Planning Commission Staff Report

April 13, 2016

- SUBJECT:** P16-0006
- APPLICANT/
PROPERTY OWNER:** The Frank Berlogar Trust
- PURPOSE:** Application for Design Review approval to construct an approximately 6,486-square-foot, two-story custom home with a 1,133-square-foot garage on an approximately 49,316-square-foot parcel
- LOCATION:** 39 Silver Oaks Court (Lot 1)
- GENERAL PLAN:** Low Density Residential and Open Space-Public Health and Safety
- SPECIFIC PLAN:** Vineyard Avenue Corridor
- ZONING:** Planned Unit Development – Hillside Residential & Open Space (PUD-HR&OS) District
- EXHIBITS:**
- A. [Draft Conditions of Approval](#)
 - B. [Project plans, Photosimulations, GreenPoint Checklist](#), and [Color and Material Board](#) dated “Received February 26, 2016”
 - C. [Silver Oaks Hillside Development and Architectural Guidelines](#)
 - D. [Ordinance No. 2096 \(PUD-84\)](#)
 - E. [Location and Noticing Map](#)

Figure 4: Cross Section of the Proposed Grading

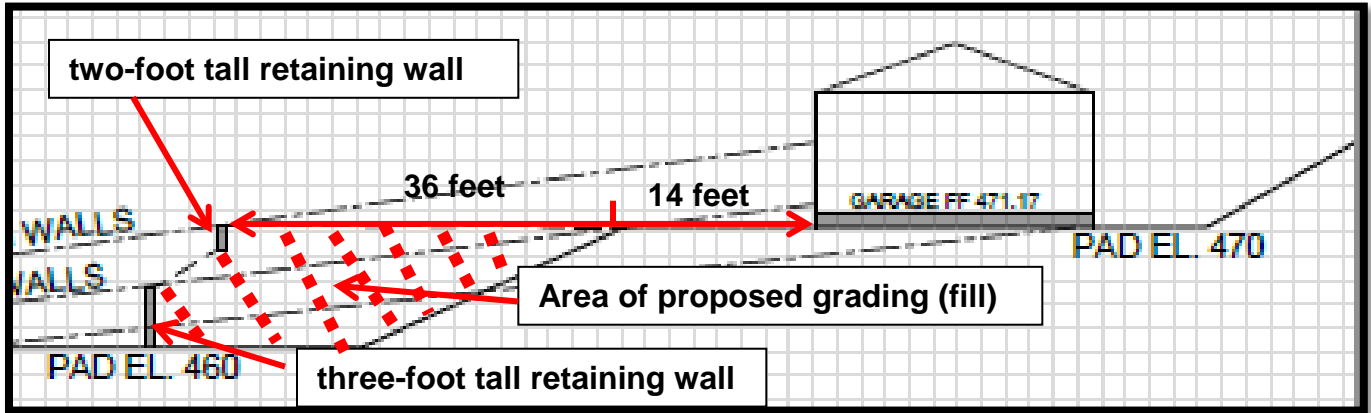
The approved design guidelines state that the building pad grading may be altered only with approval by the City. The applicant is proposing to extend the flat area in front of the garage northeasterly by an additional 36 feet to create a vehicular backup area of 50 feet in depth. An estimated 100 cubic yards of fill would be needed to create this flat area. The soil for the requested fill area would be from Lot 2 so that no off-site soil transport would be needed.

While staff appreciates the desire to create more vehicle maneuvering space through additional grading, a slightly smaller flat space would allow for easy vehicle access while retaining more of the existing topography. Taking into account that 25 feet is considered an acceptable vehicle backup distance, staff recommends that the depth of the graded area in front of the garage be reduced to 30 feet. This recommendation is reflected in Condition of Approval No.5.

To screen the retaining walls and the graded area in front of the garage, staff recommends that *Westringia fruticosa* 'Wynabbie gem' shrubs, five-gallon minimum in size, be planted at five-feet apart in the front of the retaining walls. *Westringia fruticosa* "Wynabbie gem" is a fast growing, drought tolerant, deer resistant shrub. It would grow to four- to six-feet in height

Figure 5: Proposed Elevations

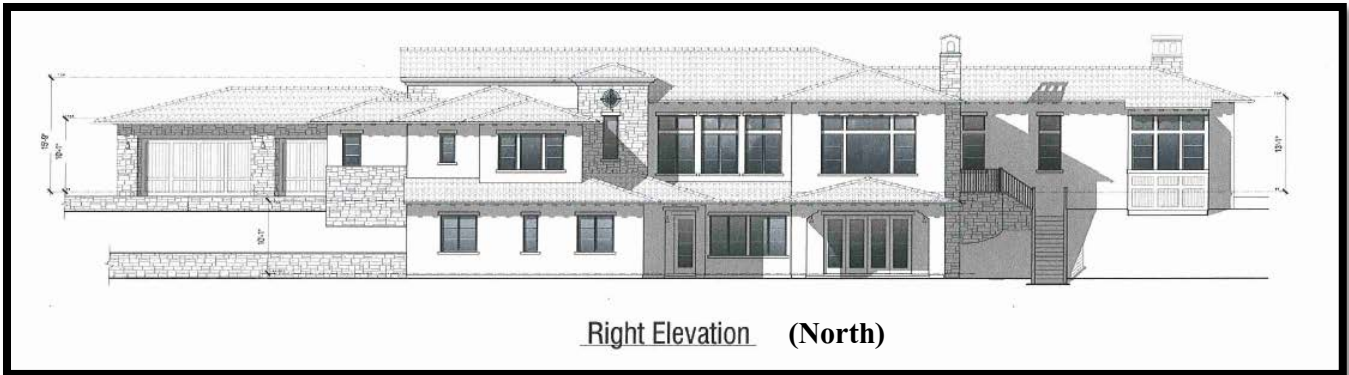
Two garage doors are proposed. As the garage would face northeast and could be visible from Silver Oaks Court, staff recommends that the garage doors be revised to four separate doors to break the massing of the garage; thus enhancing the aesthetics of the north elevation. The applicant has agreed to make this revision and staff has included a condition of approval to address this item.

Figure 5: Preliminary Landscape Plan

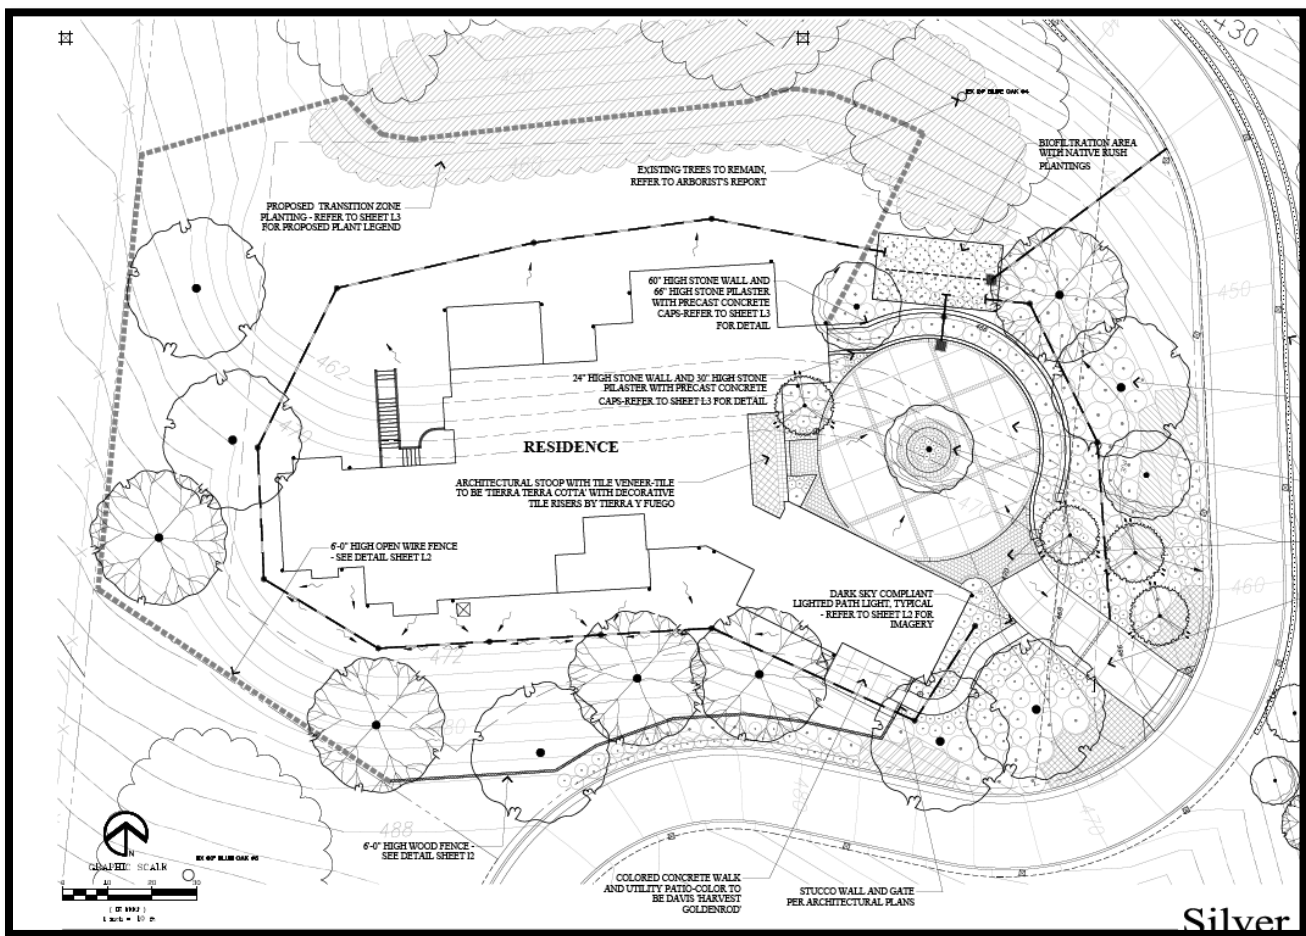
The design guidelines require a minimum of 24-inch box size trees. The proposed landscape plan includes a total of 17 new trees throughout the plan, all 24-inch box size. No existing site trees will be removed in conjunction with this project. Figure 5 shows the proposed landscape plan.

Staff believes the proposed landscaping would be adequate for the site as required by the design guidelines. The combination of plant materials and hardscape will add interest to the site and the existing trees and the proposed shrubs at the retaining walls will provide adequate screening of the site from Old Vineyard Avenue and the surrounding area. Additionally, with the proposed condition requiring the project to meet the Model Water Efficient Landscape Ordinance (WELO), the proposed landscaping will minimize the need for portable water.
